SUBJ: **Addendum 1 – Clarifications to the Specifications and Responses to Vendor's Questions**

BID ITEM: **Bid Item #23-150 Construction - Airfield Electrical System Upgrade for Runways 5-23 & 11-29 for Augusta, GA – Daniel Field Airport**

ADDENDUM NO. 1

2 WIRING DIAGRAM
E12 NOT TO SCALE

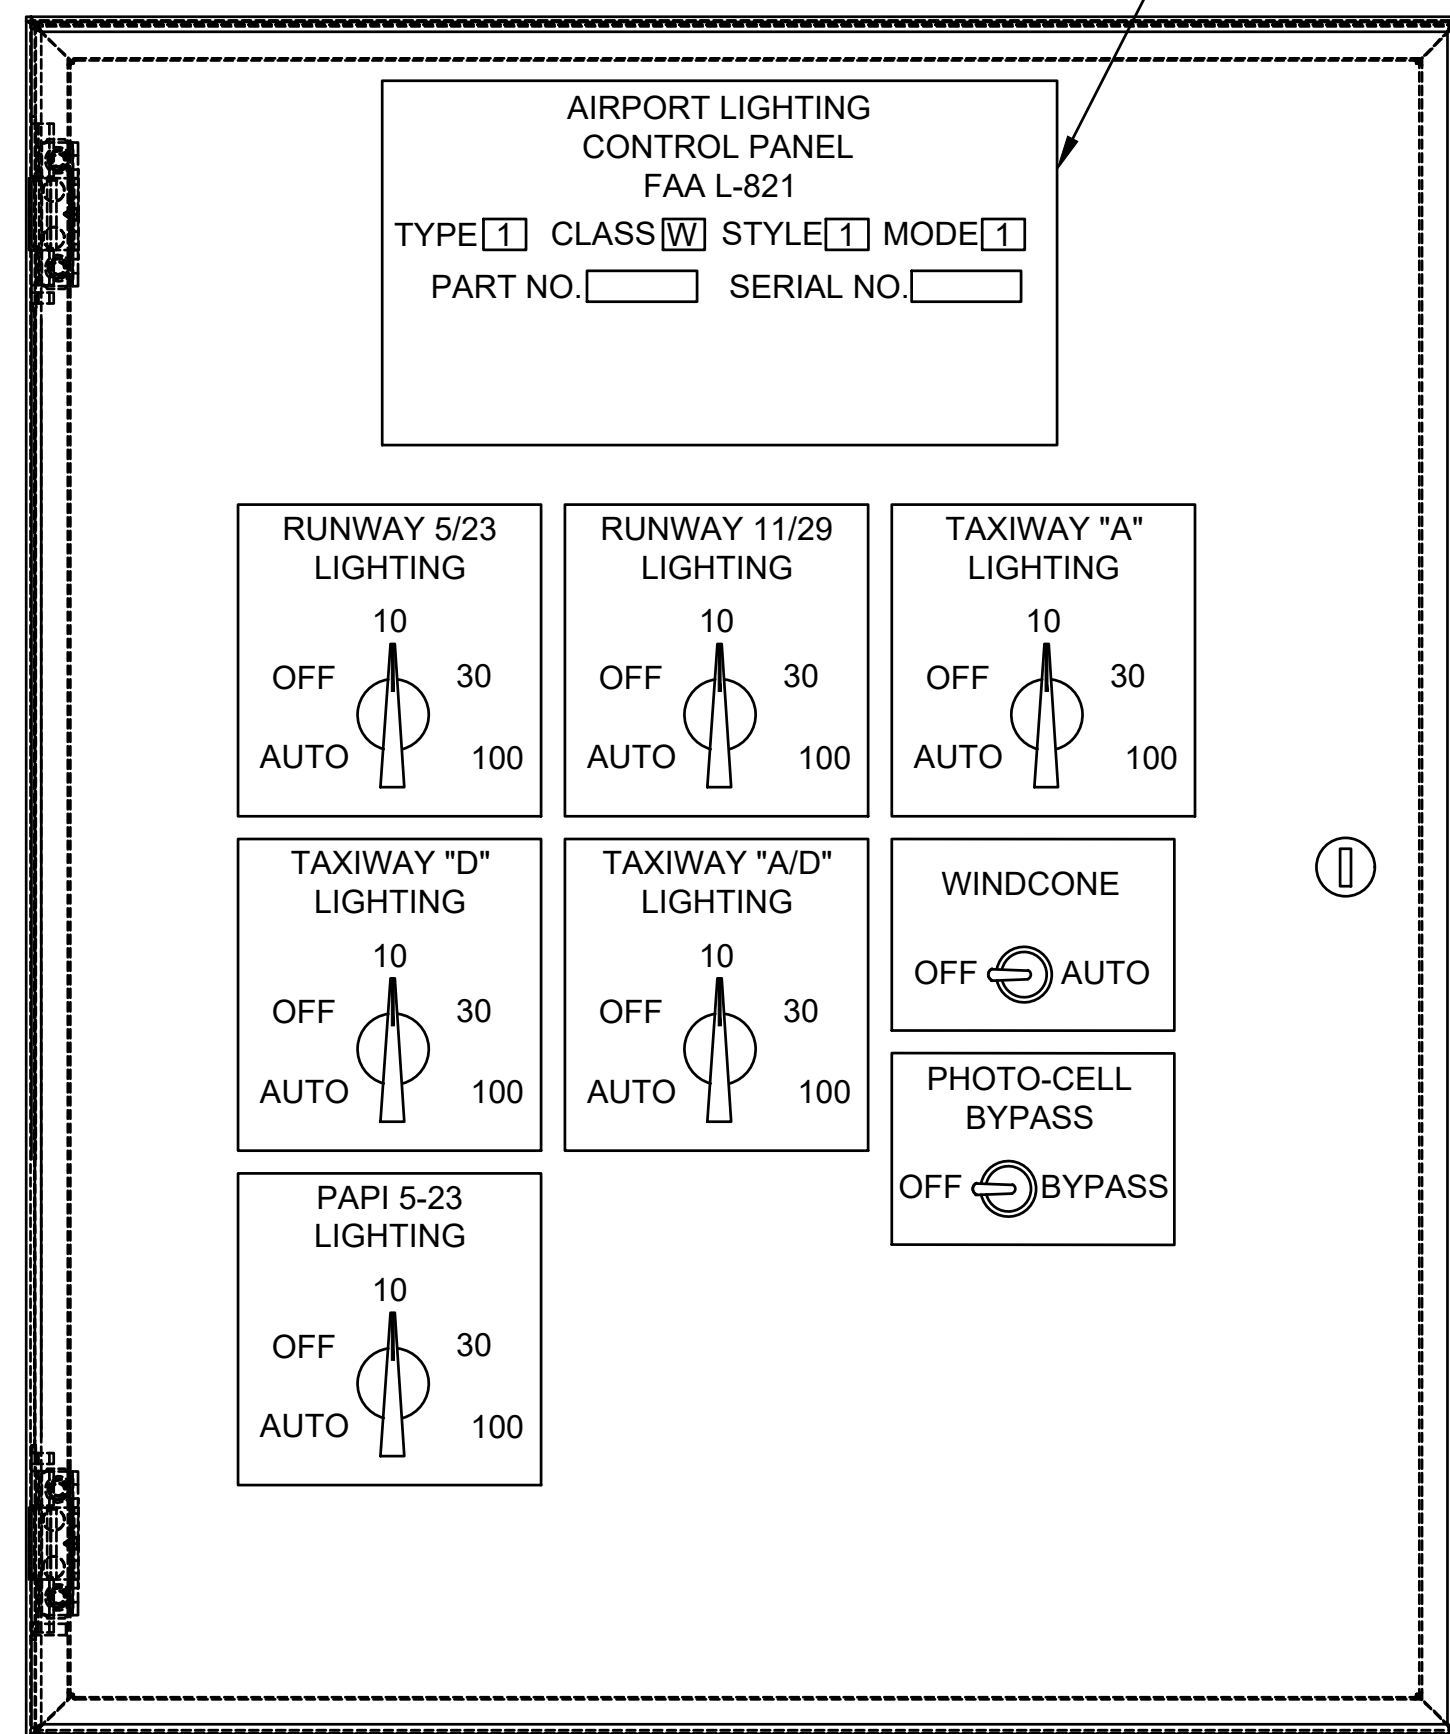
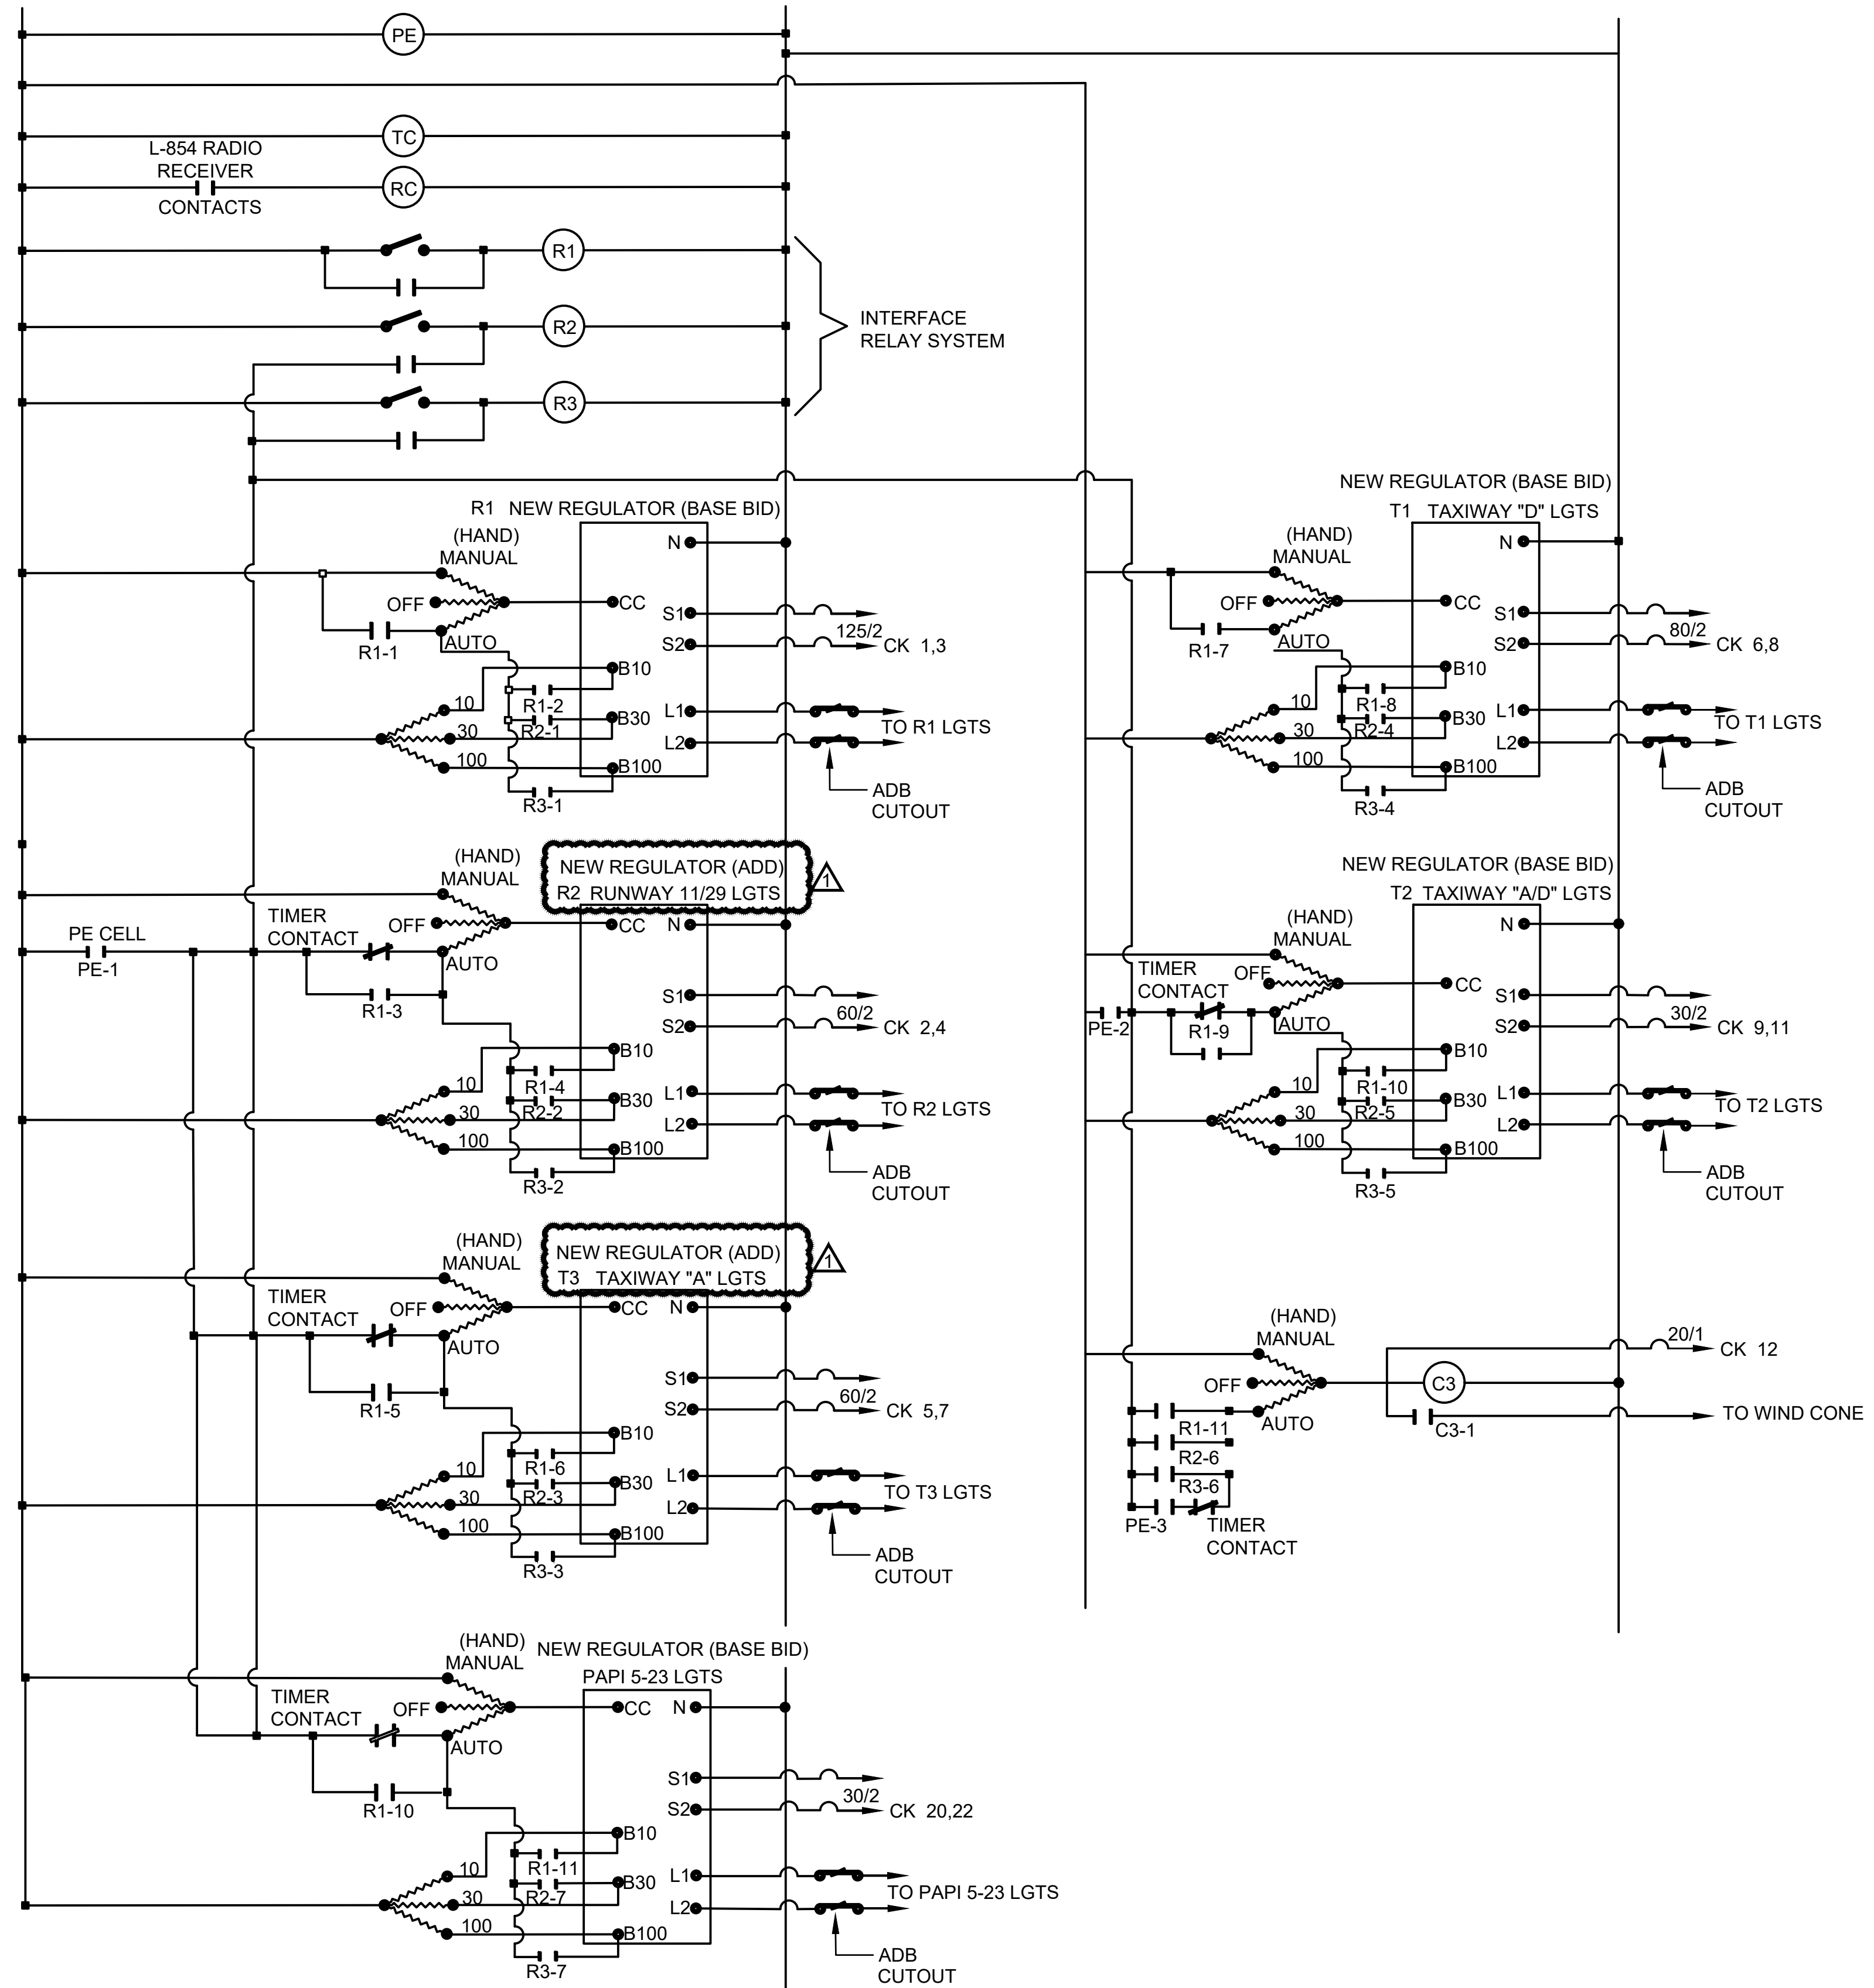
- ALT (Alternate) abbreviation and wording revised to ADD (Additive Bid).
 - Airport Lighting Control System Notes 1 and 2 Revised to state:
Between Dawn to Dusk, the new photocell locate in the vault building shall automatically set all lighting systems to its low setting or as directed by owner.
Between Dusk to Dawn, the new photocell located in the vault building shall automatically set all the lighting systems to its high setting or as directed by owner.

**AIRFIELD LIGHTING
 & WIRING PLAN
 - RUNWAY 11/29
 -PART 1 (ADD)**

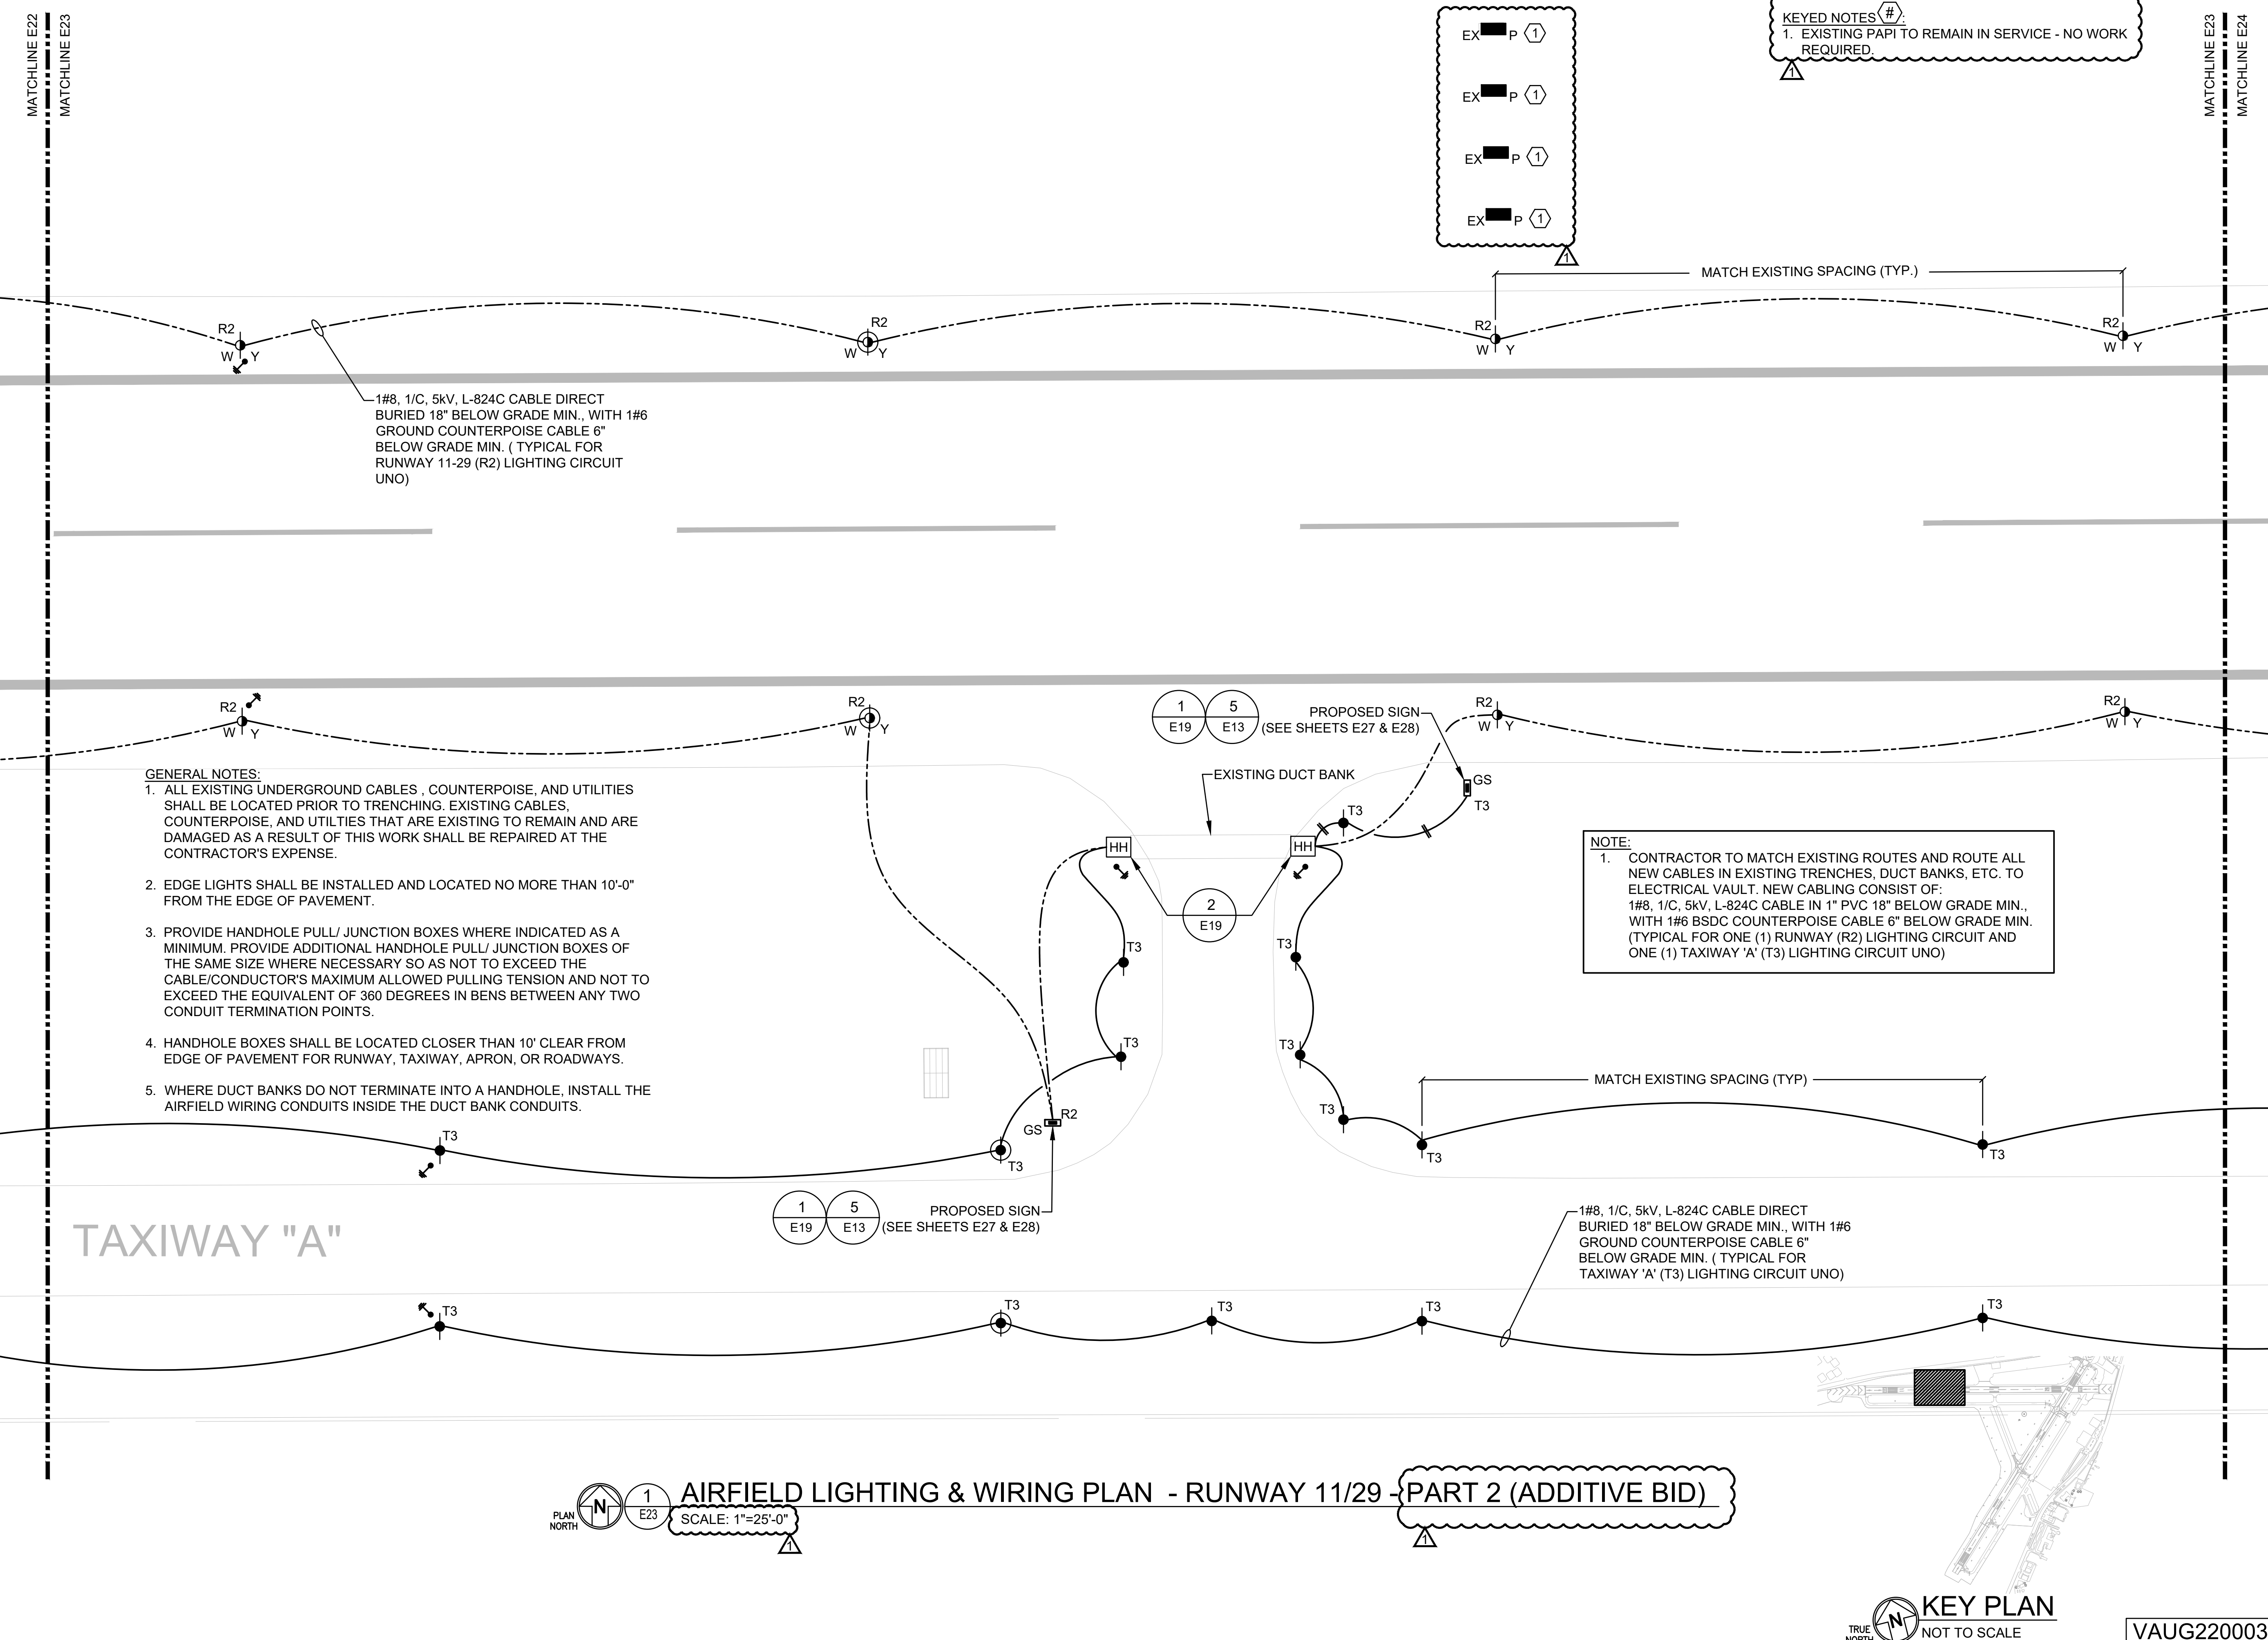
- Scale of this sheet revised from 1"-50' to 1"-25'.
 - Deleted all Field Lightning Arrestors.
 - Deleted Keynote 1 associated with Field Lightning Arrestor.

- Keynote 2 revised to Keynote 1.
 - ALT (Alternate) abbreviation and wording revised to ADD (Additive Bid).
 - Circuit Wiring/Routing shown for Runway 11/29 (R2) & Taxiway A (T3) Circuits.
